Knox Pit M-2017-036

CONSIDERATION OF A 112C PERMIT APPLICATION WITH
OBJECTIONS

JARED EBERT, COLORADO DIVISION OF RECLAMATION,
MINING AND SAFETY

DRMS PRESENTATION – RECOMMENDATION FOR
APPROVAL WITH CONDITIONS

FIGURE 17
PREDICTED DRAWDOWN AT THE END OF
PHASE 2

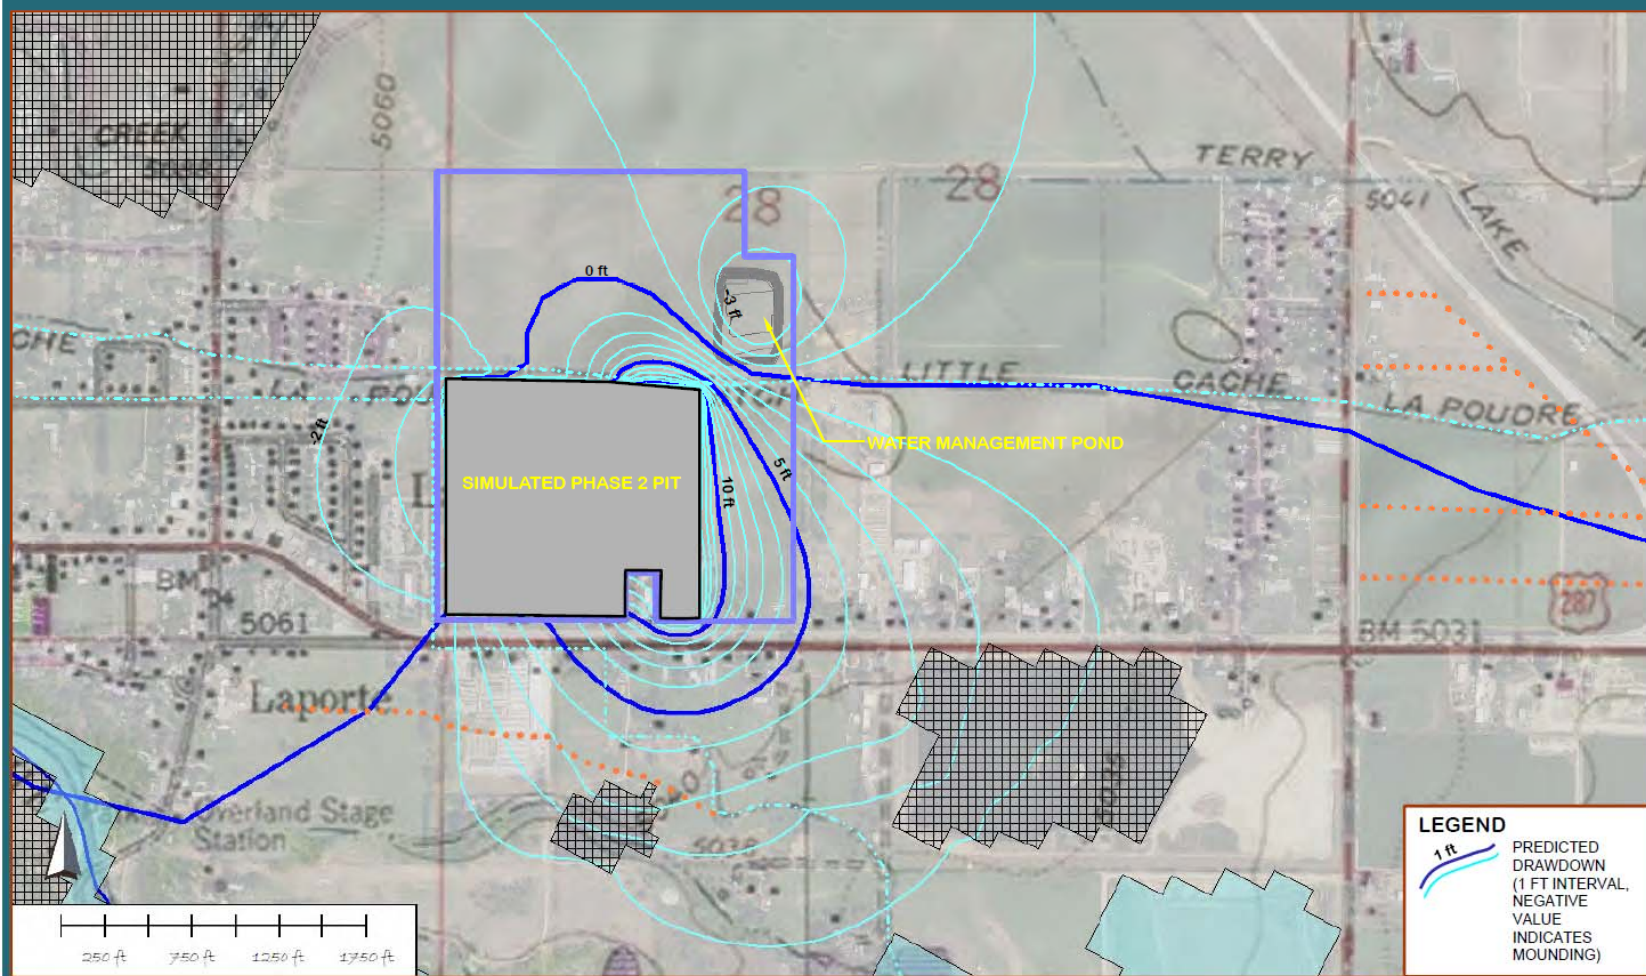
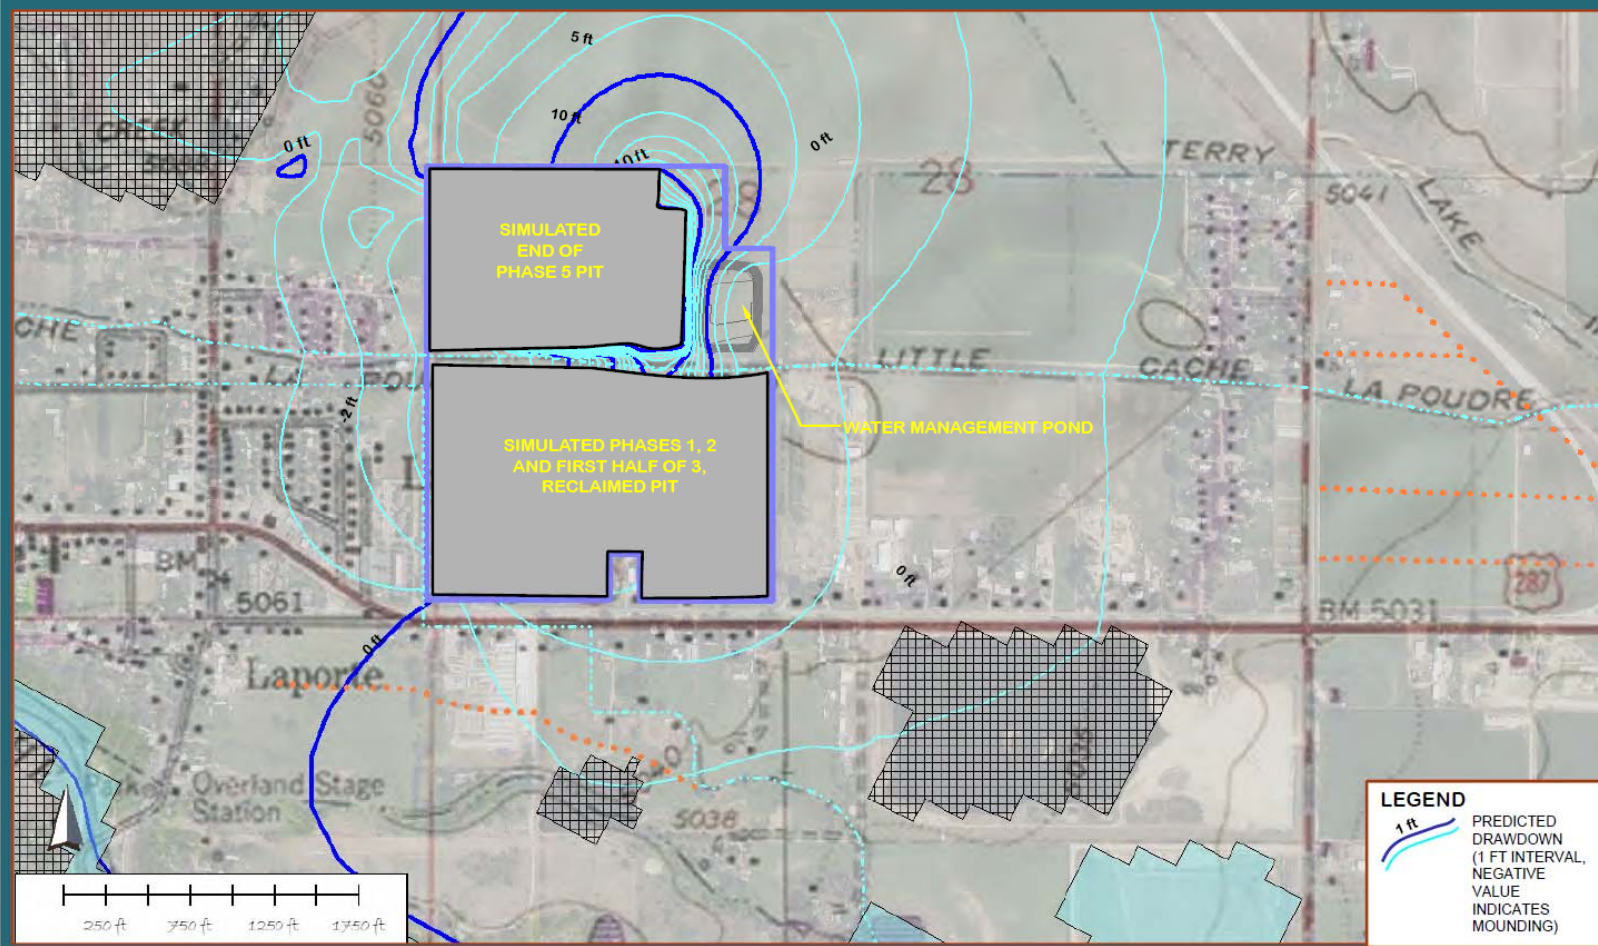
- ▶ *Concerns regarding the impact of the mining operation on the surrounding groundwater levels. Concerns regarding the effectiveness of the proposed perimeter drain.*
-

- ▶ LRM predicted effects of dewatering and drawdown of alluvial aquifer:
 - ▶ Largest off-site drawdowns
 - ▶ While mining north of Little Cache La Poudre Ditch
 - ▶ No wells known to exist in this area
 - ▶ Five wells predicted to be impacted by drawdown south of the mine.
 - ▶ Cherry, West, Morgan Timber(2) and Plantorium
-

- ▶ 5 foot drawdown trigger for possible mitigation if necessary
- ▶ Mitigation Measures
 - ▶ Provide a water tap from West Fort Collins Water District
 - ▶ Deepening wells
 - ▶ Re-introducing pumped groundwater through leach field or injection well back into the aquifer near the impacted well.

Mounding of Groundwater

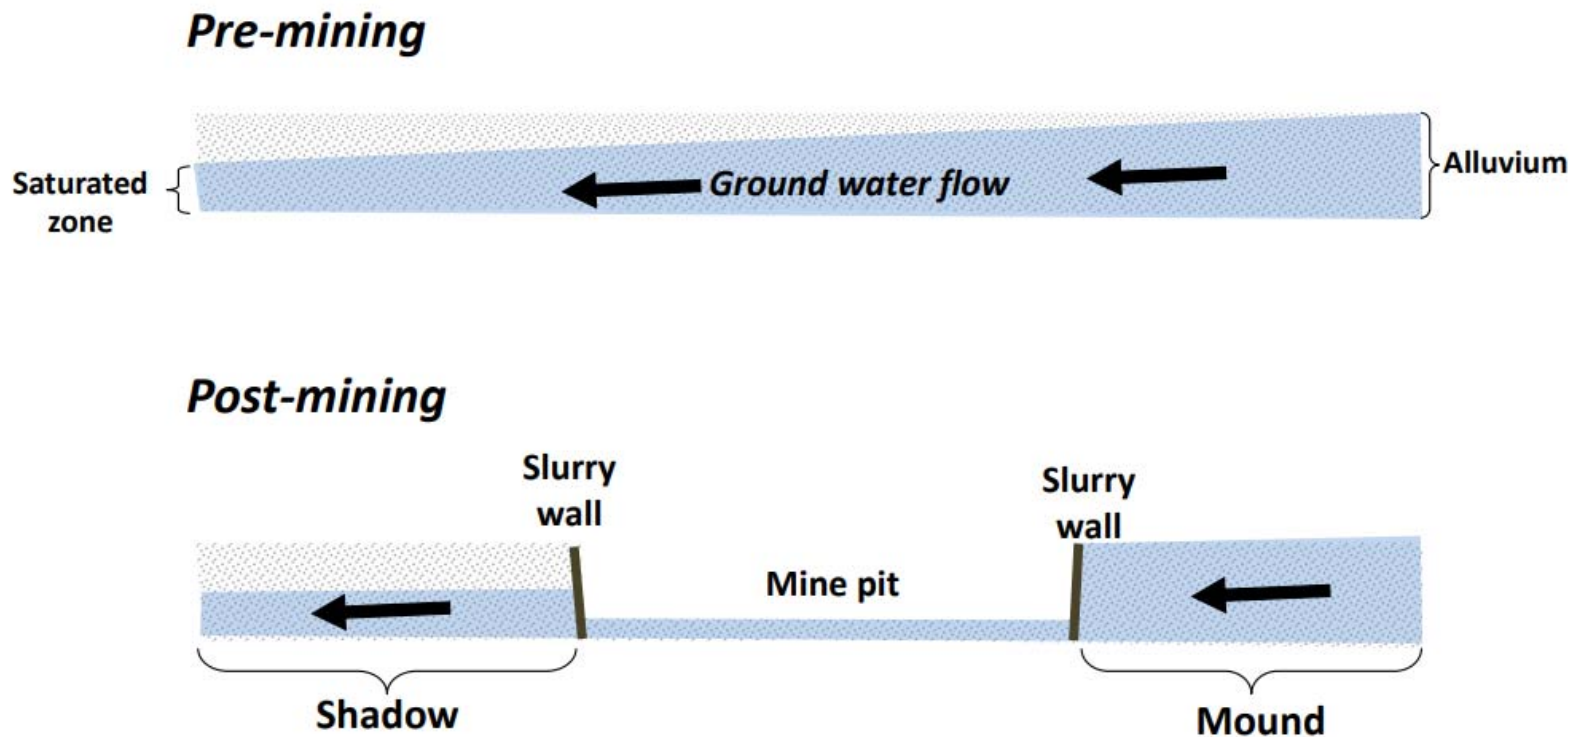
- ▶ Groundwater model predicts mounding may occur:
 - ▶ Up gradient of the pits west boundary
 - ▶ Adjacent to Water Management Pond

- ▶ Monthly water level monitoring
- ▶ 2 foot water level rise will trigger mitigation
- ▶ Mitigation measures:
 - ▶ Perimeter drain
 - ▶ Pump from the perimeter drain
 - ▶ Increase perimeter drain capacity by adding another drain higher in the profile
 - ▶ Implementing siphons from the perimeter drain

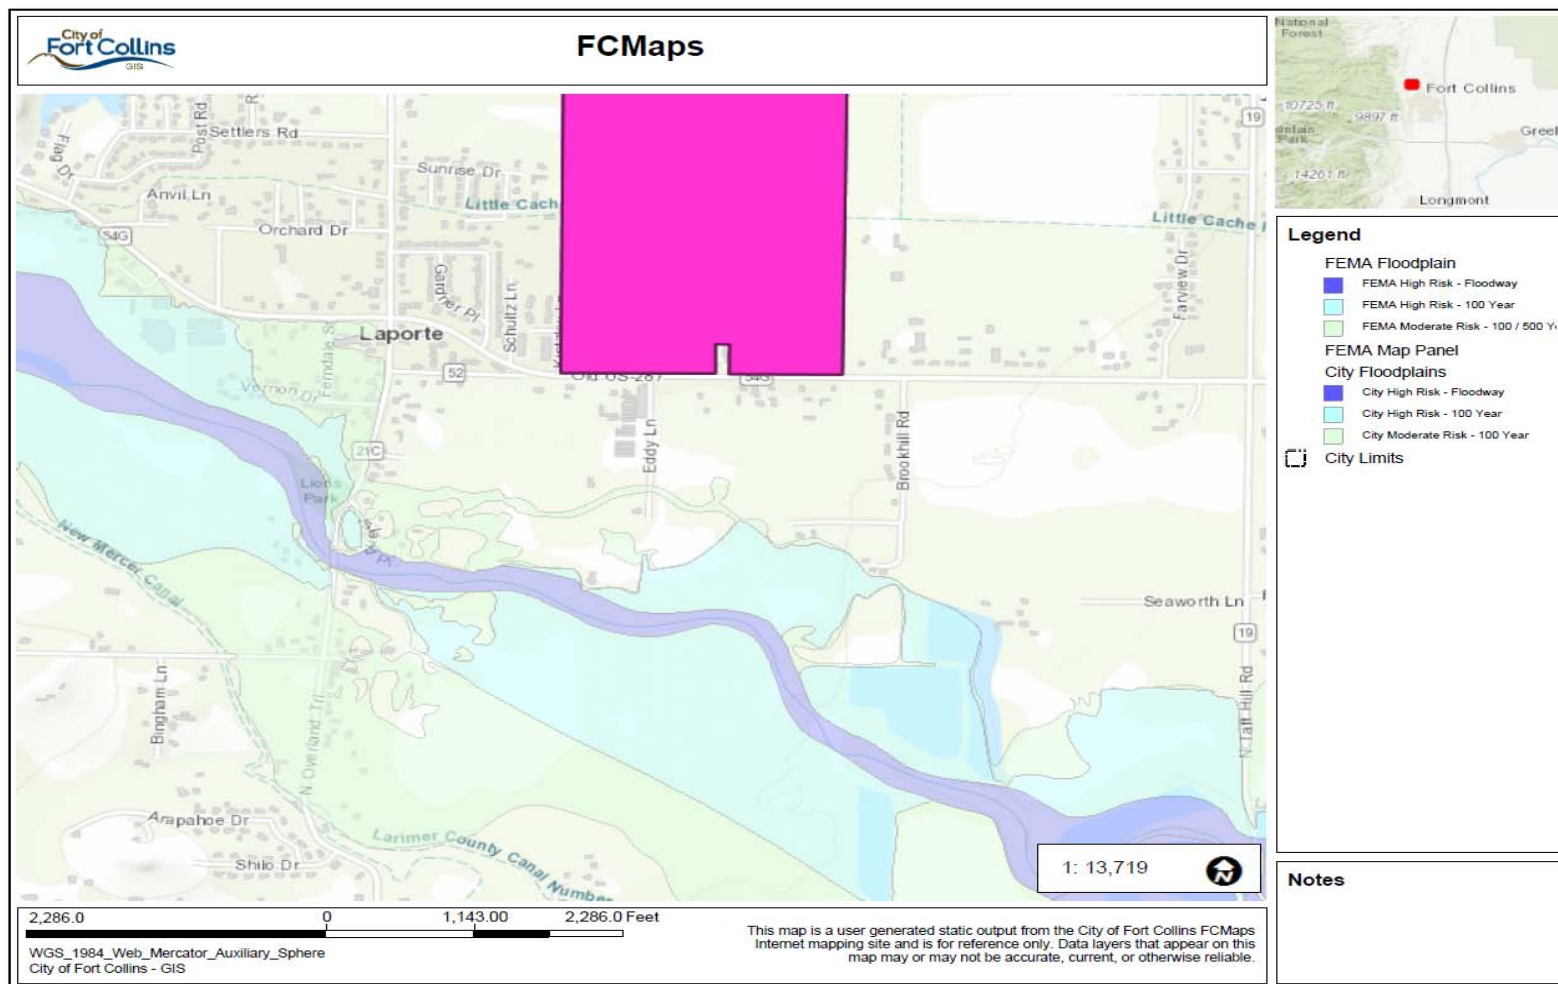
- ▶ *Concerns regarding the impact of groundwater drawdown on adjacent trees.*
 - ▶ Site not located within a riparian area
 - ▶ Adjacent ornamental vegetation likely more reliant on surface water irrigation
 - ▶ LRM's proposed plan to mitigate the impacts to adjacent well owners to insure use of their wells for irrigation continues, the Division finds the operation will not adversely affect the surrounding vegetation.

Figure 5. Loveland Ready Mix Knox Project Adjacent Raptor Locations

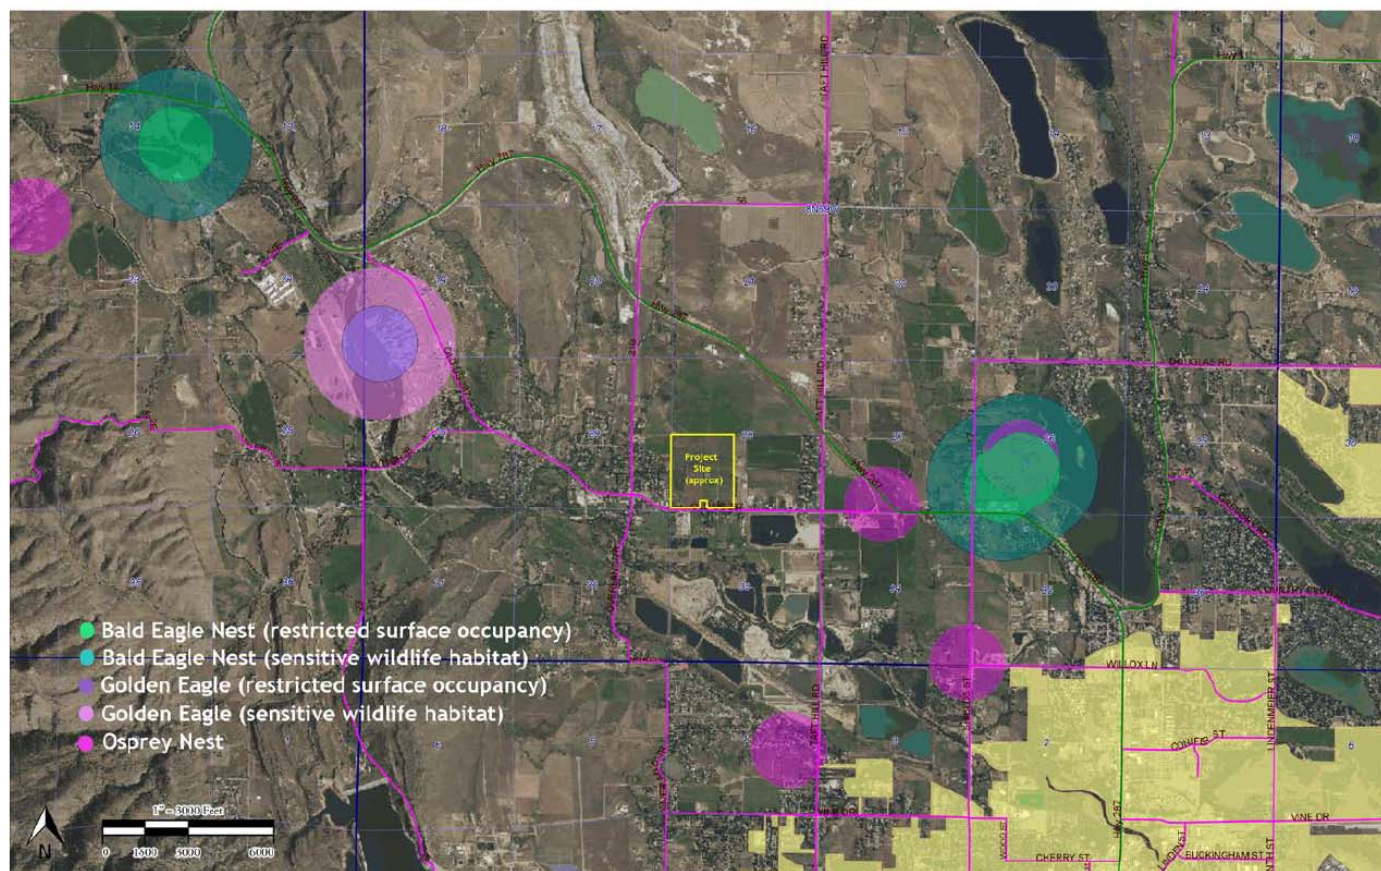
- ▶ *Concerns regarding the impact the mining operations will have on raptors.*
 - ▶ January 30, 2018 Avian Survey – No raptor nests found within the site or adjacent to the site.
 - ▶ Raptor nests found 1 to 4.6 miles from the site.
 - ▶ LRM commits to a raptor nest monitoring plan.
 - ▶ CPW data show no active raptor nests in the immediate area of the proposed application
